10 Holland Drive, Rye

Attached please find the septic design plan I would prepare for 10 Holland Drive if the system were in failure, which it is not. The Cadys have provided me with an inspection report that says the leach field is in "good" condition. Suggested repair work on the septic tank has been completed.

RE: 10 Holland Dr. - Rye, NH - Building Permit Application

Replacement Septic System Design required by Rye Bldg Dept, NO EXPANSION System not failed, preliminary delivered (not submitted) to Town of Rye, AOS paperwork not yet obtained. Talked Bldg Inspector out of requiring state approved plan due to Catch 22 of failed vs. not failed requirements.

10 HOLLAND DRIVE 9-18-17.pdf 511K

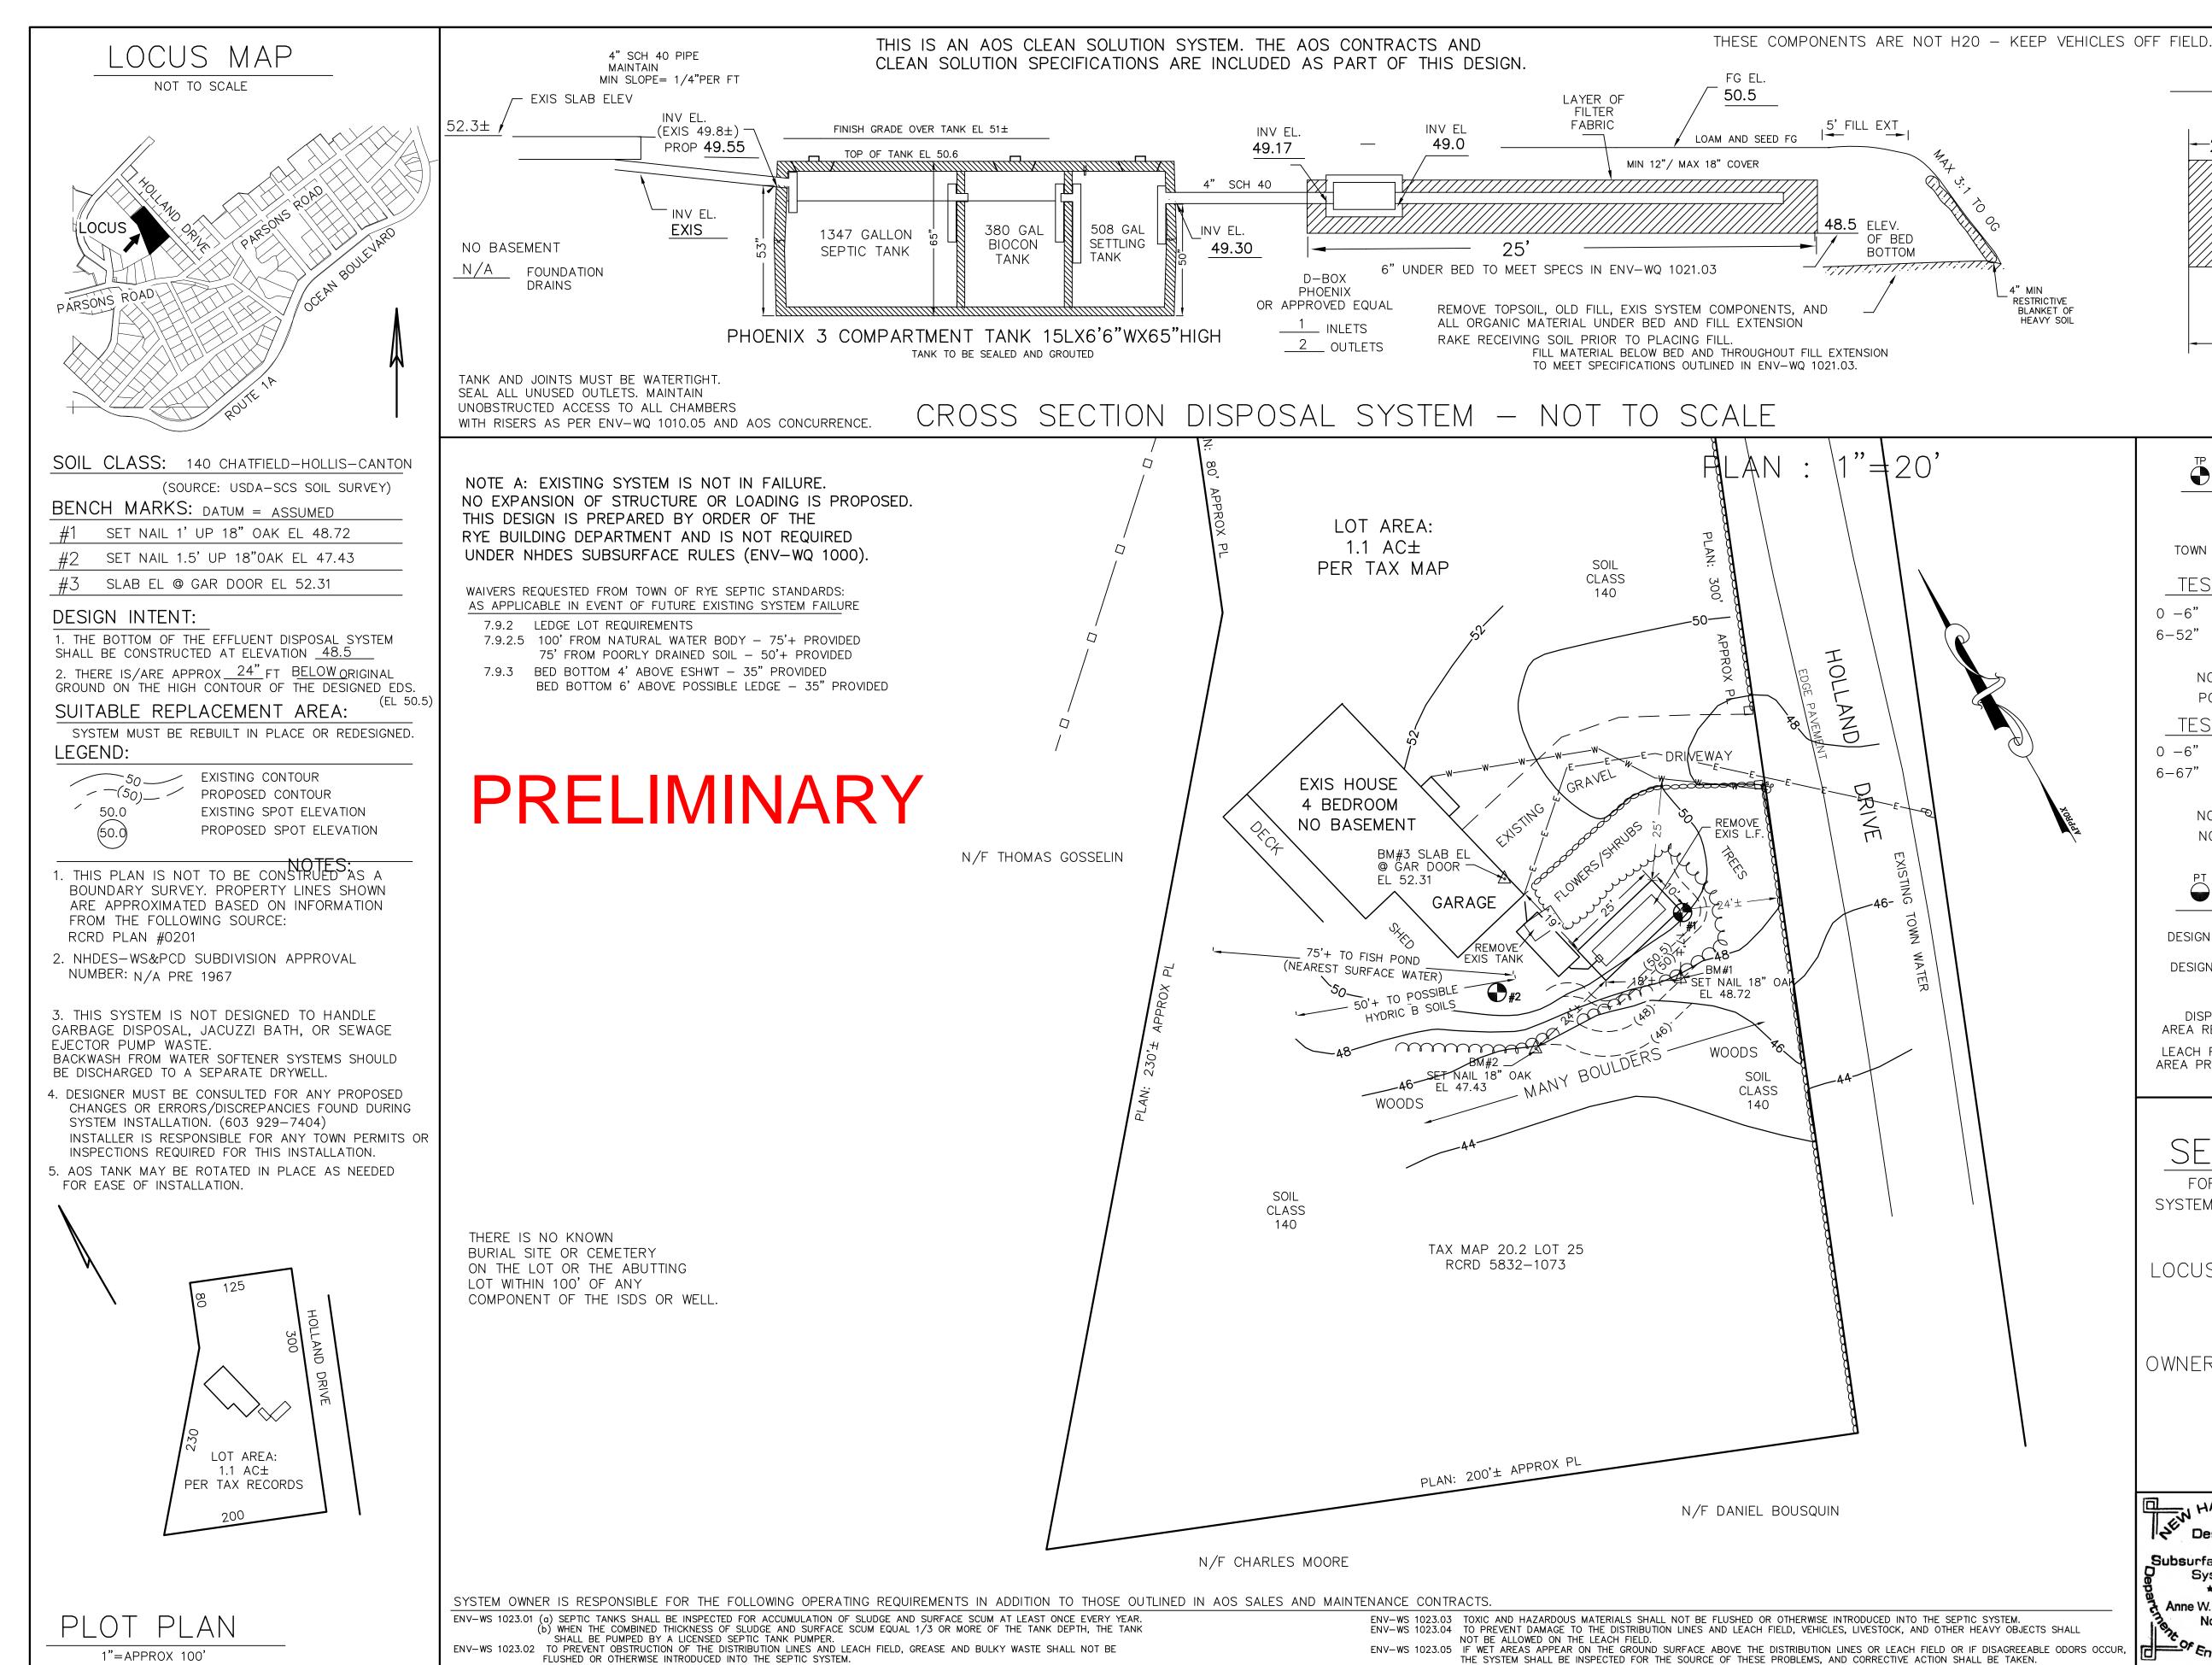
You have required design and state approval of a replacement system to be installed in the event of future system failure, indicating that you can waive town requirements as needed on behalf of the Town of Rye.

I have discussed this plan with Dawn Buker at the Subsurface Bureau. I have told her that the structure is undergoing renovations but that no change in the building footprint or gross living area, and no expansion of septic loading is proposed. She has indicated to me that:

- 1. If the system is in failure, a replacement system must be both approved and installed.
- 2. If the system is not in failure, neither the reduction of separation from SHWT nor the customary waivers granted for failed system replacement can be approved by Subsurface.

To get state approval I would have to design a system that would never be installed. What would be the point of that?

3. Based on my representation of the facts, DES approval is not required in this case.

What this means is that I cannot get state approval for the replacement system that I believe should be installed if the system were to fail unless it actually fails, which it has not. I do not think it is in anyone's interest to prepare a design for something that would never be installed and have to do it again if and when failure occurs. It has been suggested that perhaps having a Town approved plan in the file might be enough to alleviate your concerns, especially since Subsurface does not require state review.

Who made the repairs to the tank? Did you get to verify them?

I will keep this plan on file in the event of a failure. Tell you client they can move ahead without the state approval.
